## PRODUCT CHANGE NOTIFICATION (PCN)

### A-MCU60030/B MODULAR CABLE

CHANGE NOTIFICATION: PCN 20220509\_A-MCU60030/B

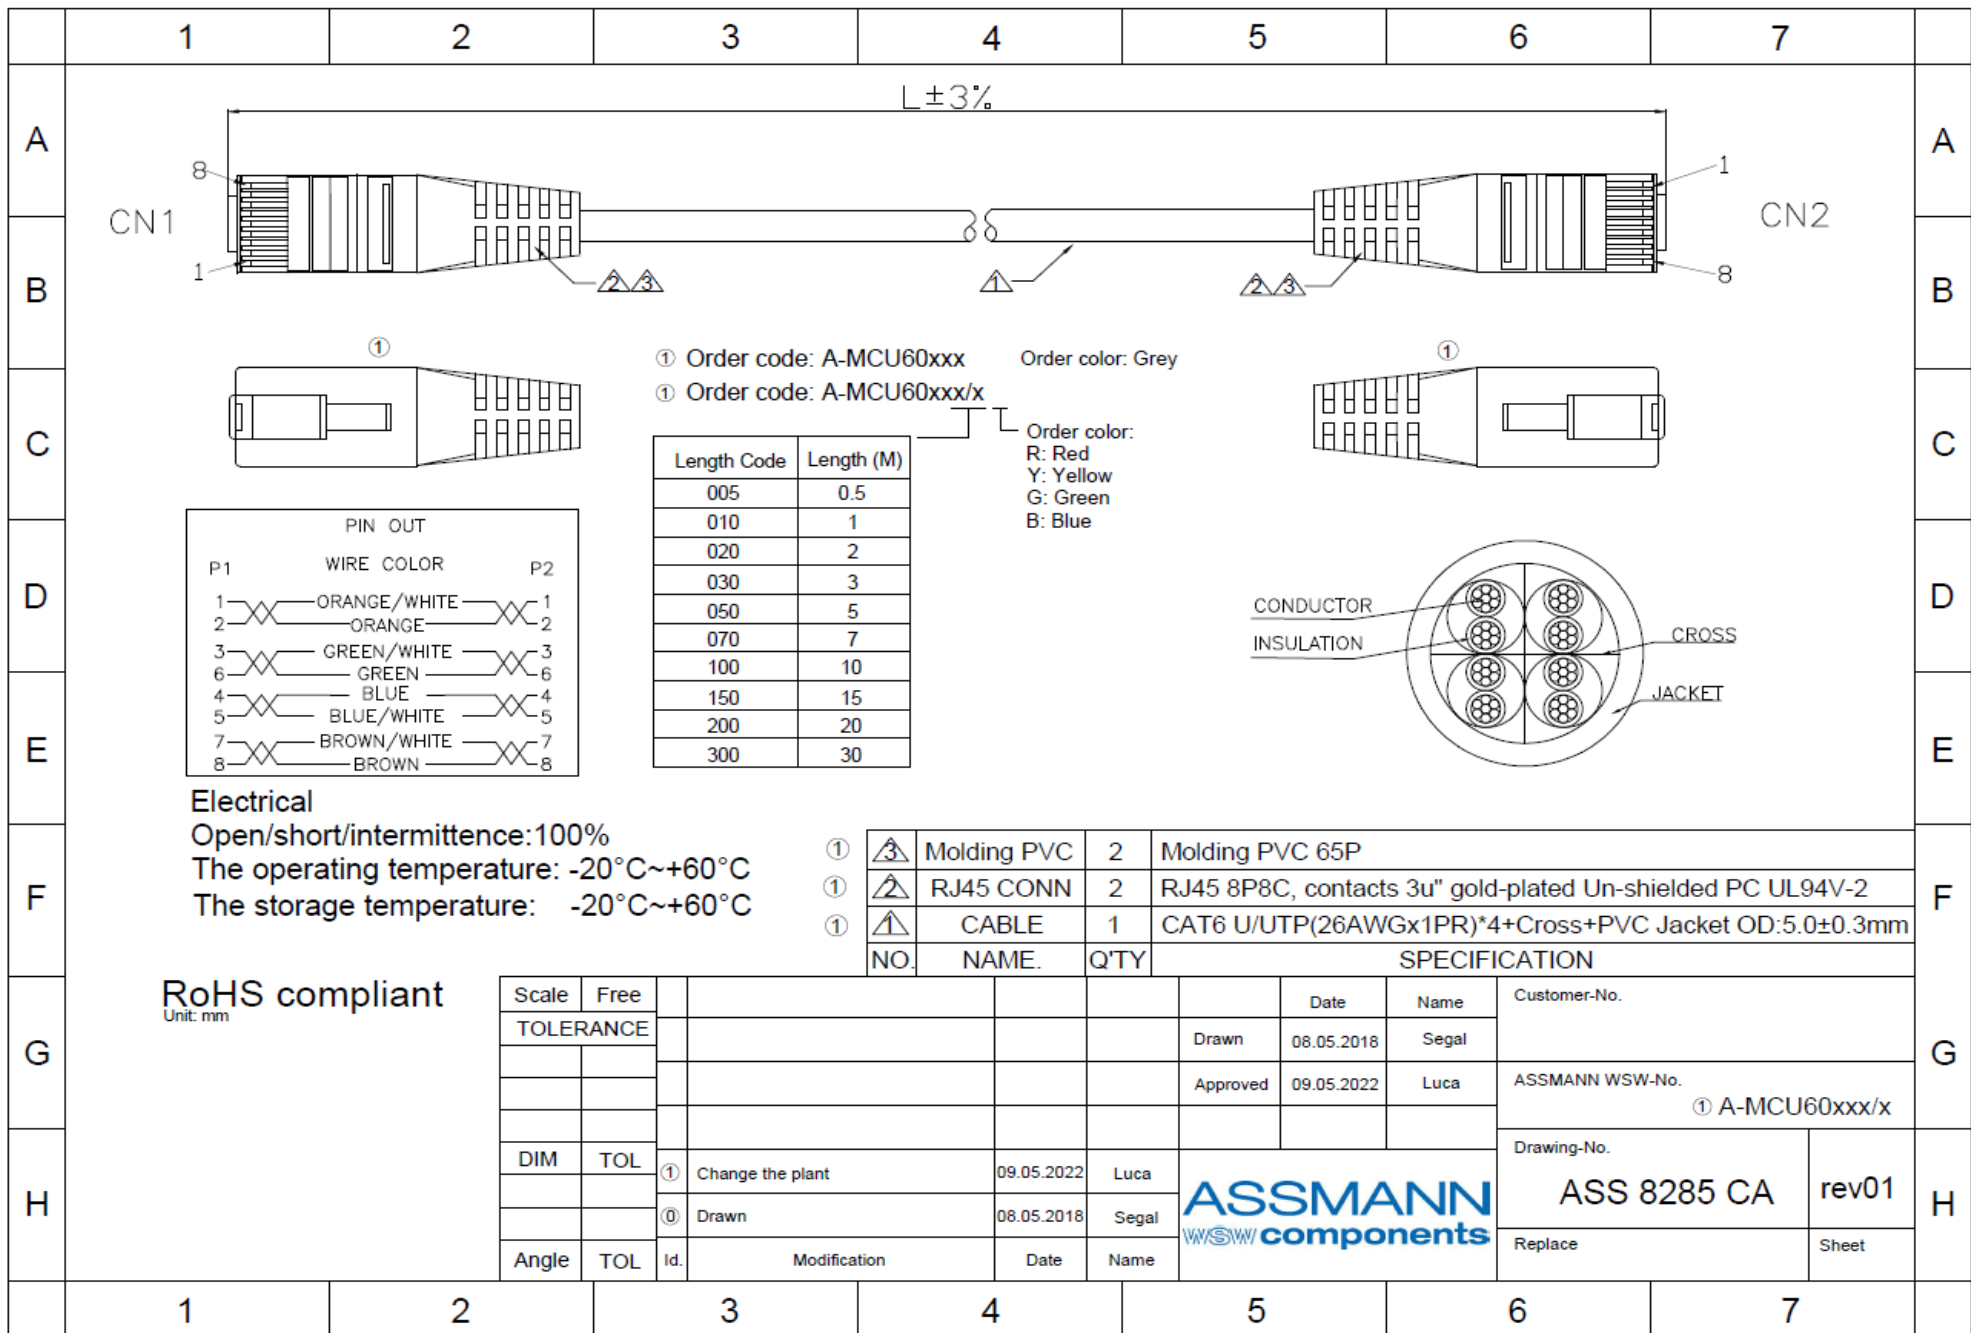
DESCRIPTION OF CHANGES: CHANGE OF DATA SHEET  
CHANGE OF DATA SHEET  
New Draw.-No. ASS\_8285\_CArev01

REASON FOR CHANGE: CHANGE OF PRODUCT LOCATION  
CHANGE OF PRODUCT LOCATION

① Order code: A-MCU60xxx      Order color: Grey  
 ① Order code: A-MCU60xxx/x      Order color:  
 R: Red  
 Y: Yellow  
 G: Green  
 B: Blue

①	△	Molding PVC	2	Molding PVC 65P	①	△	RJ45 CONN	2	RJ45 8P8C, contacts 3u" gold-plated Un-shielded PC UL94V-2	①	△	CABLE	1	CAT6 U/UTP(26AWGx1PR)*4+Cross+PVC Jacket OD:5.0±0.3mm	NO.	NAME.	QTY	SPECIFICATION	
①	△	Molding PVC	2	Molding PVC 65P																	
①	△	RJ45 CONN	2	RJ45 8P8C, contacts 3u" gold-plated Un-shielded PC UL94V-2																	
①	△	CABLE	1	CAT6 U/UTP(26AWGx1PR)*4+Cross+PVC Jacket OD:5.0±0.3mm																	
NO.	NAME.	QTY	SPECIFICATION																		
<p>FOR DETAIL, PLEASE TAKE ATTACHED NEW DRAWING: FOR REFERENCE</p>
